Staff Report

Re: Central Station West Apartments - PLNPCM2020-00187 & PLNPCM2020-00647 –
Planned Development & Design Review

Planned Development & Design Review

PROPERTY ADDRESS: 577 West 200 South
MASTER PLAN: Downtown Plan (2016)
ZONING DISTRICT: GMU – Gateway Mixed Use Zoning District

Sheet Title
Overall Floor Plan Level 1

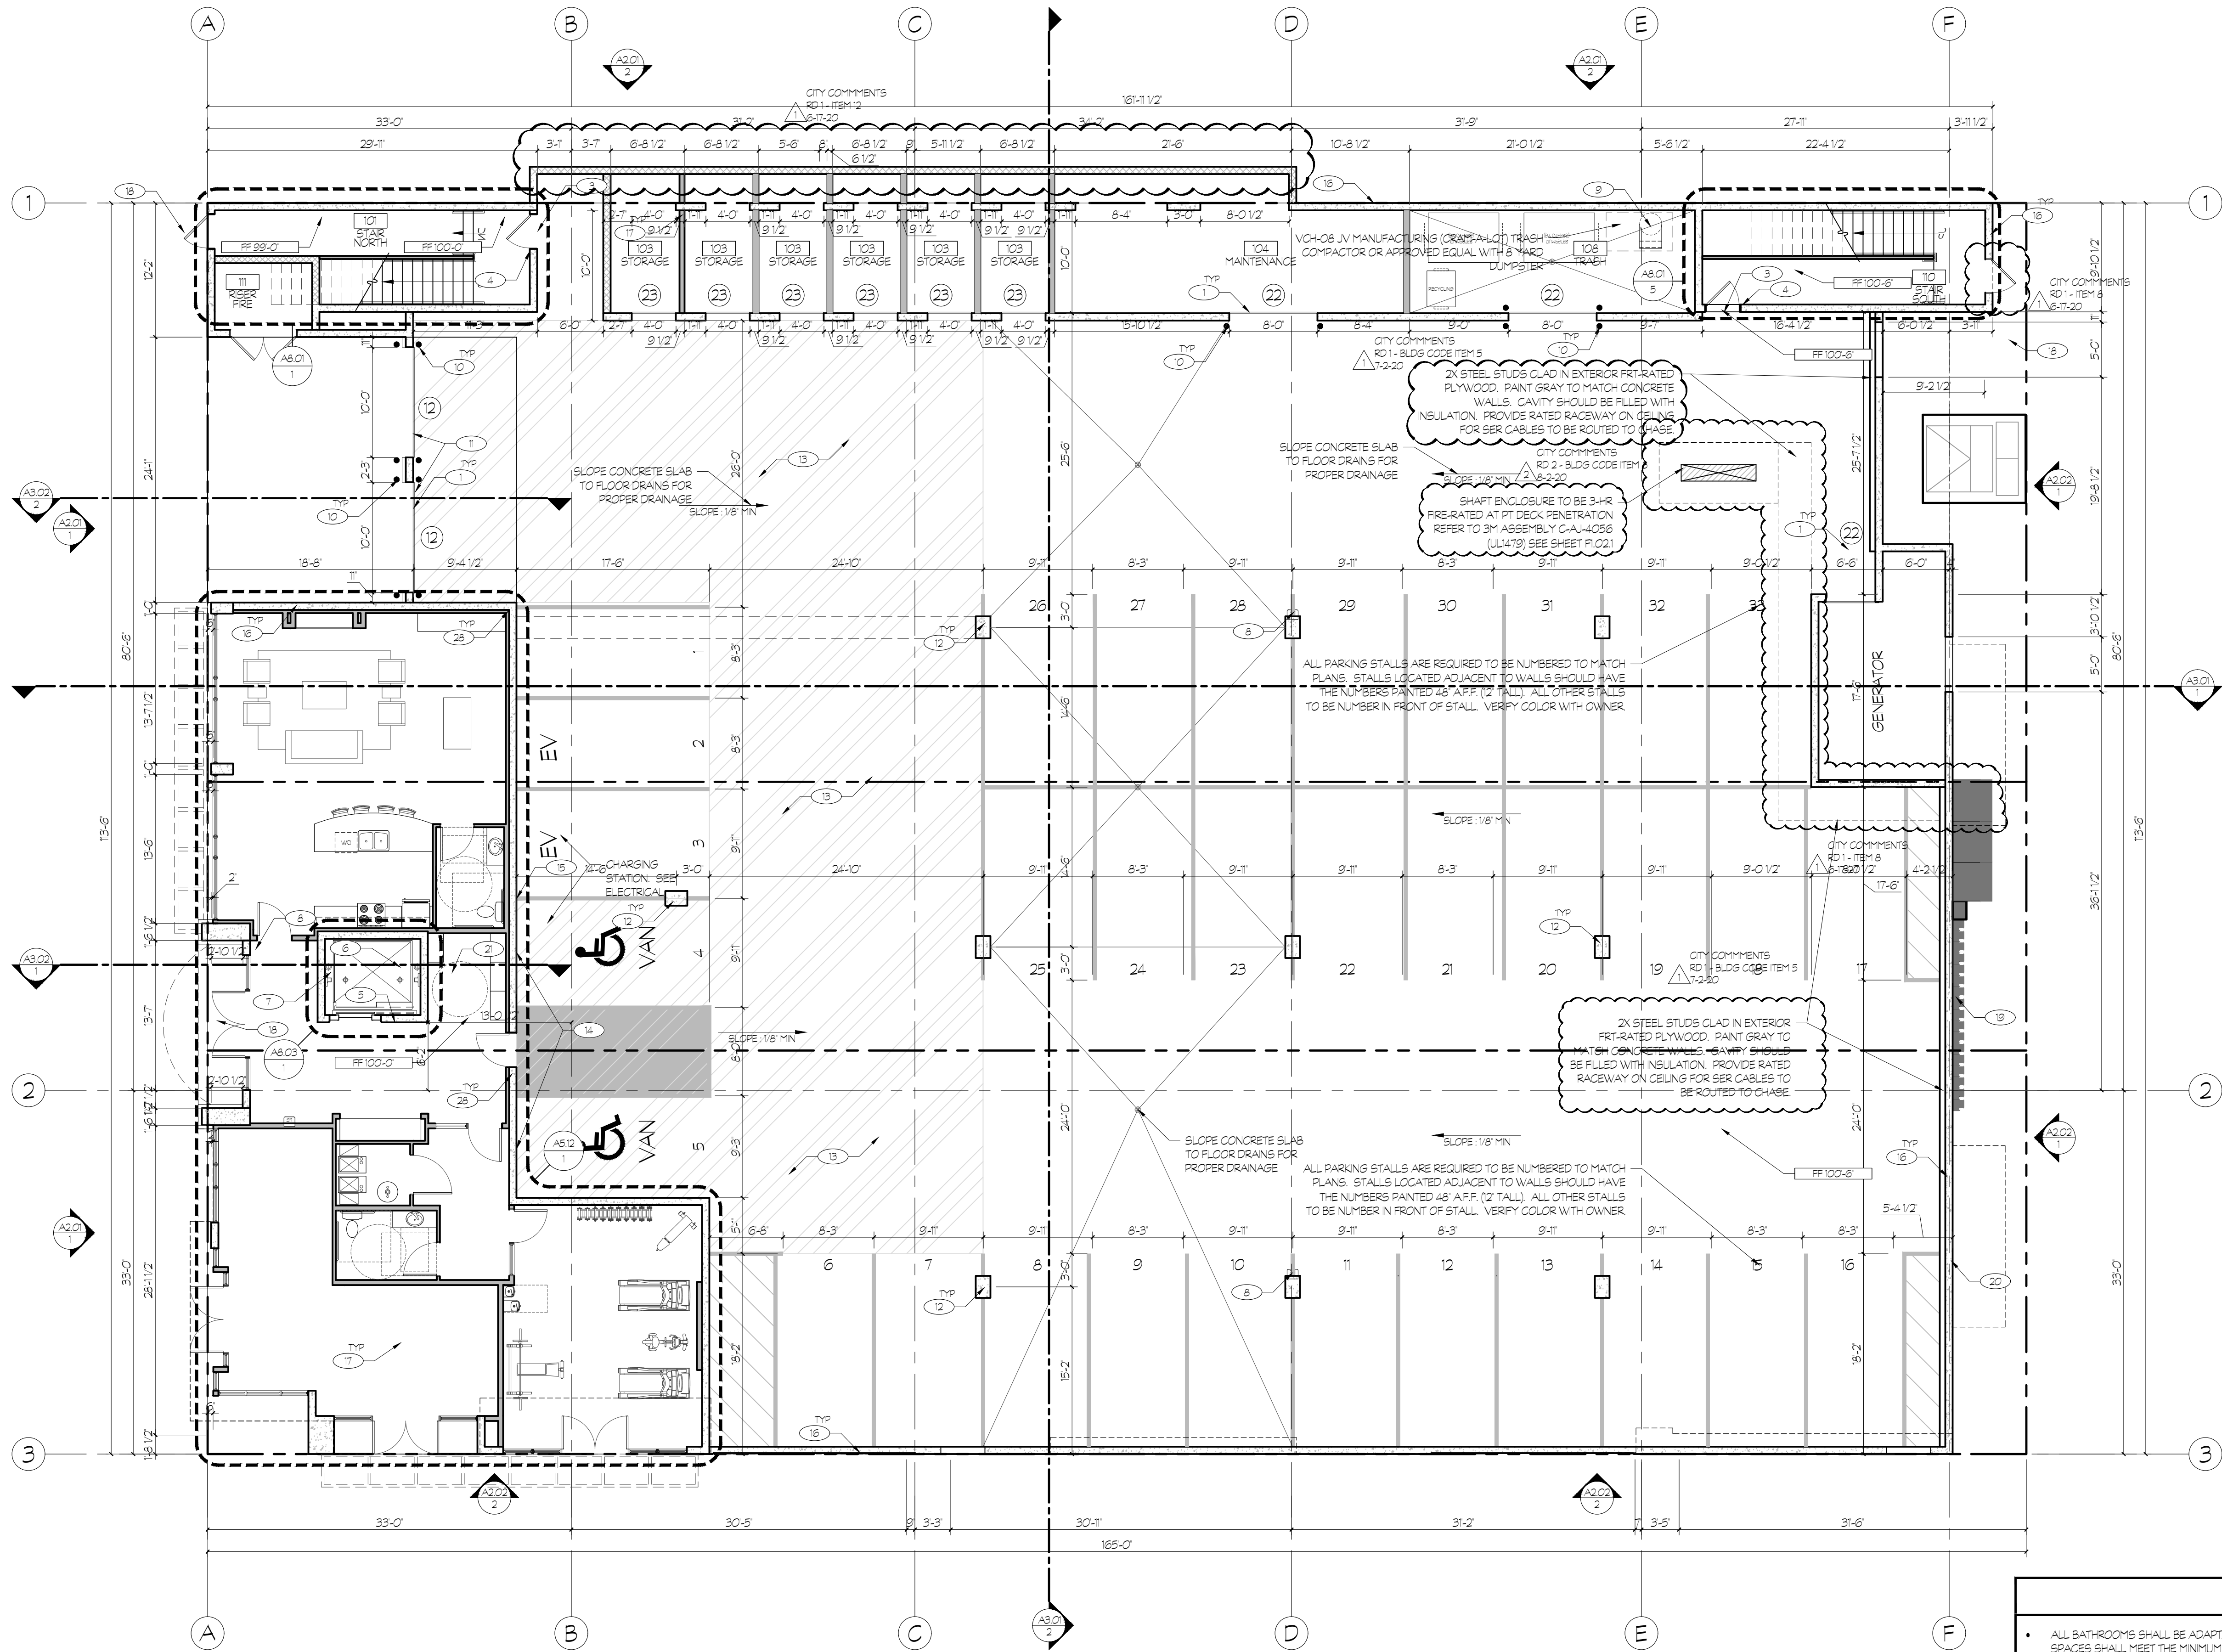
Sheet A0.01 thru A1.08, & A2.01 Per IBC1023.3 interior exit stairways and shall terminate at an exit discharge or a public way. The south stairway does not discharge at the public way or lead to a public way. It is landlocked by the property lines from the adjacent parcels.
